Rock Mountain Detention Facility

Management Update June 2023

Anti-ligature Update

Air Vents

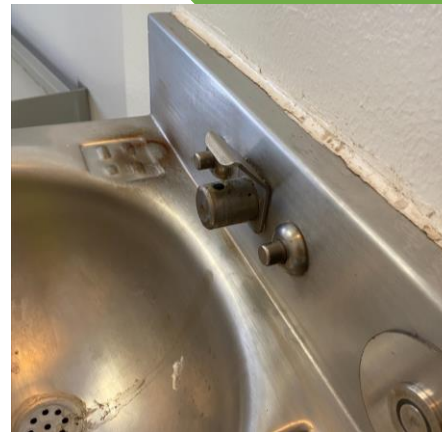
Supply and return grilles shall have openings no greater than 3/16 inch

1231.2.10 Exercise Area

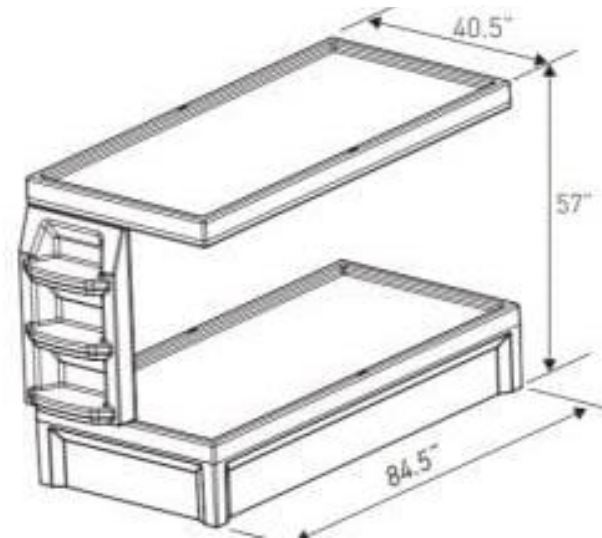
The minimum clear height must be 15 feet.
